Access Compliance Report

Public Rights-of-Way

(Curb Ramps)

Intersection ID: 15089	Main Street: FAIRWOOD_AV	Cross Street: YOUNGBLOOD_ST	Location: E
ADA ID: C8A94FA3B85D	Ramp Type: PerpDiag	Initial Pass/Fail: Fail	Overall Compliance: No
Severity Score: 12.5			
Codes/Mitigation Info/Possible Solution		Field Measurements/Component Compliance

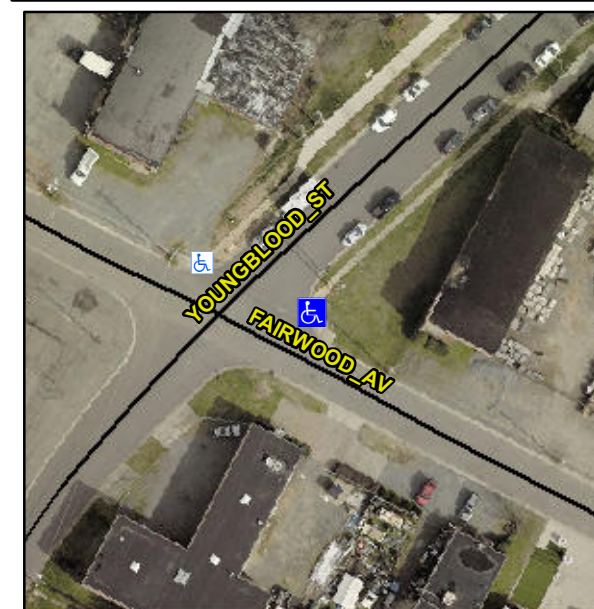
Not Found, R304.2.2

Compliance	Description	Data	Compliance	Description	Data
N/A	Ramp Length (in)	54.0	No	Ramp Slope (%)	9.1
Yes	Ramp Width (in)	48.0	Yes	Ramp XSlope (%)	0.6
N/A	Flare Type LT	N/A	N/A	Flare Type RT	N/A
N/A	Flare Slope LT (%)	N/A	N/A	Flare Slope RT (%)	N/A
N/A	Flare Traversable LT?	N/A	N/A	Flare Traversable RT?	N/A
N/A	Landing Length (in)	N/A	N/A	DWS Provided?	N/A
N/A	Landing Width (in)	N/A	N/A	DWS Contrast?	N/A
N/A	Landing Slope (%)	N/A	N/A	DWS Length (in)	N/A
N/A	Landing X Slope (%)	N/A	N/A	DWS Full Width?	N/A
N/A	Landing Curb? (Y/N)	N/A	N/A	DWS Offset (in)	N/A
N/A	Shared Landing?	N/A			
N/A	Gutter Ponding?	N/A	N/A	Gutter Slope (%)	N/A
N/A	Gutter Lip Ht (in)	N/A	N/A	Gutter X Slope (%)	N/A
N/A	Painted X Walk1?	No	N/A	Painted X Walk2?	No
	X Walk 1 Direction	To NW		X Walk 2 Direction	To SW
N/A	X Walk 1 Width (in)	N/A	N/A	X Walk 2 Width (in)	N/A
	X Walk 1 Slope (%)	1.4		X Walk 2 Slope (%)	0.1
	X Walk 1 X Slope (%)	0.2		X Walk 2 X Slope (%)	0.0

Remove & Replace Curb Ramp With Two New Directional Ramps or Equivalent.
